Appendix F: Design Midlands Response

Leaford Solar Farm Application - Landscape Comments

Design:Midlands are working with Stafford Borough Council in providing expert landscape input on Leaford Solar Farm application (reference 24/38719/FUL). This has involved Fiona Heron (Landscape architect) undertaking a thorough site visit with Dryden McNair Lewis and Vanessa Blake from Stafford Borough Council officers including a briefing on the site history and local context and undertaking an assessment of the planning application, specifically the Landscape and Visual Impact Assessment (LVIA).

2.1 Strategic Approach to location of panels & Red Line/Development Boundary

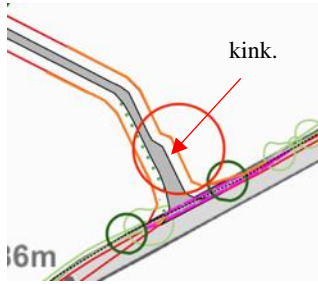
- Hedgerows and existing field patterns generally define locations of panels though there are a number of exceptions primarily related to topography or screening.
- The red line boundary does not always follow the hedgerow lines or field pattern and splits Field 5. The red line boundary at fields 15/16, 17 appears to respond to the topography however mitigation indicated in the LEMP for 17 is outside the red line boundary. This presents potential legal problems.

Proposed hedge bend & narrowing

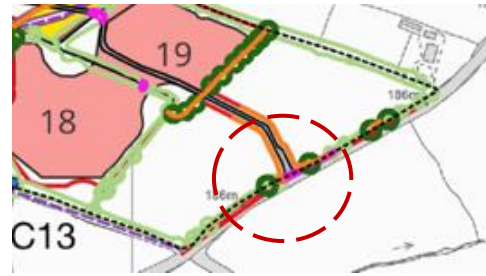
- Localised sections of hedgerow or planting will be removed for a 4m wide access track.
- Vehicular access is provided from Saverley Green Road with a resulting large visibility splay of 160m and 46m of hedgerow will need to be trimmed to 1.05m high.
- The access track between 18 and 19 bends to avoid tree loss on Saverley Green Road.
- The reduction of the width and how this point is treated however is unnatural, man-made and unsympathetic to the context.
- The double hedgerow at the entrance (view 2c below) is not characteristic of the area. This new planting/ hedgerow will be permanent so will need sensitive landscape treatment.
- The approach here will have a negative impact on the character and nature of the road which is currently lined on both sides by verges and a well maintained hedgerow.
- The approach here needs further consideration.

LVIA View 2a currently from Saverley Green Road towards field 19

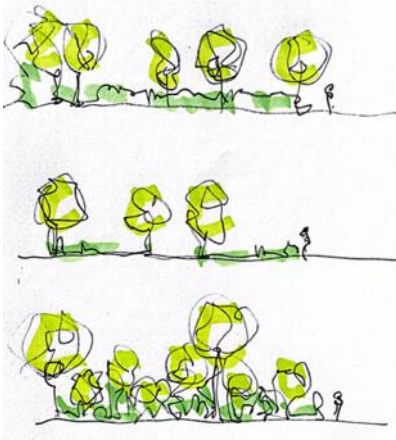
- The photographic montages below [View 2 from the LVIA] show that panels 18 and 19 are not likely to be visible from the road and there is additional planting on the border of 19.

Current hedgerows, stream, path and solitary tree with new hedgerow from Little Leacroft farm

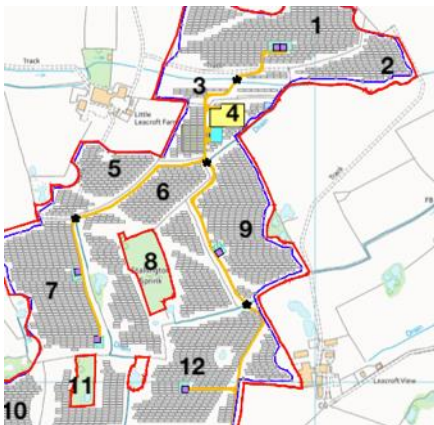
- There is a logic to infilling/adding trees and extending existing east-west hedgerow between 3 and 4 towards Little Leacroft Farm.

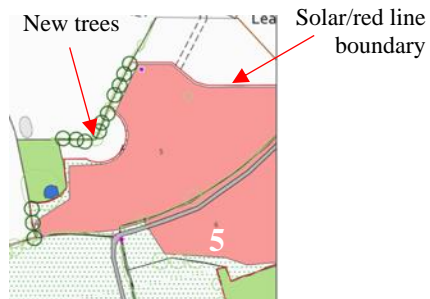
- There are areas in the ecology management plans where it is indicated in an orange line that “Proposed native Hedge species are maintained to greater than 3.5m”. These are often outside the boundary and in some instances it is not clear that these hedgerows exist for example on the southern boundary of field 15

View on C3 towards horizon following PRoW with 2 distinct 'navigational' trees and style

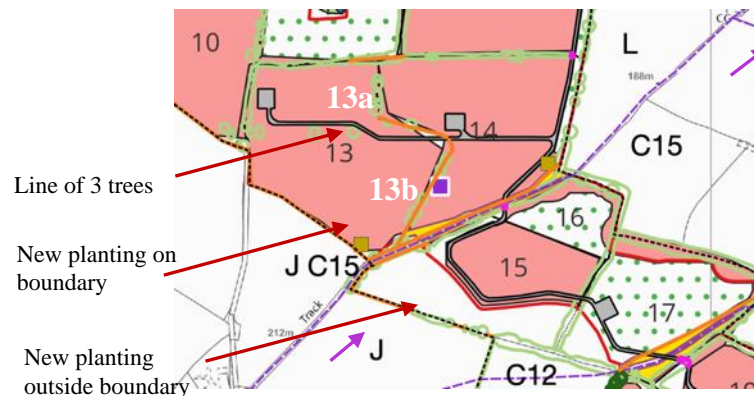
- This is long-distance route through the churchyard, with a visible style leading to the more open countryside beyond. The land rises directly to face the horizon interrupted at points by hedgerow and trees. To the west are clear views of gently undulating open countryside with characteristic hedgerows (sometimes gappy) and groups of trees and to the east similar open ground with the rising hill obscuring any view of the site.
- No sign of the sight will be visible from this point until the top of the ridge is reached prior to the next style.

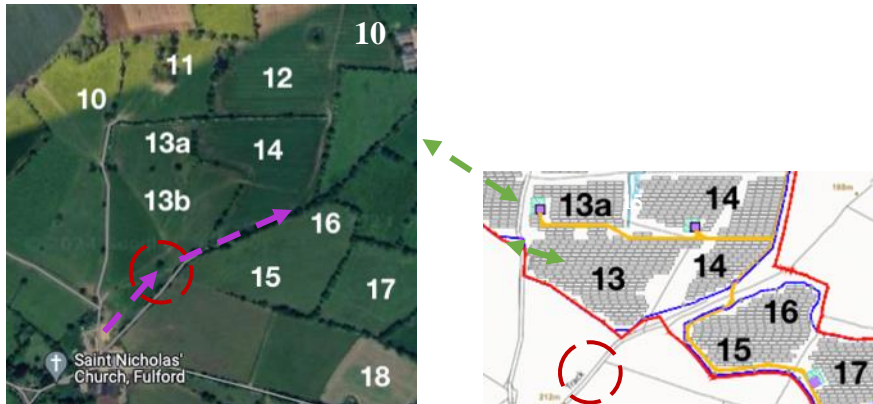
- There are a number of isolated trees outside the site to the south of the boundary of 13. There are also 3 existing mature trees on site which separate what is indicated as 13a

and 13b. Whether these were part of a remnant hedgerow and could contribute to screening could be considered and also the impact of planting in 13b and whether there should be panels here.
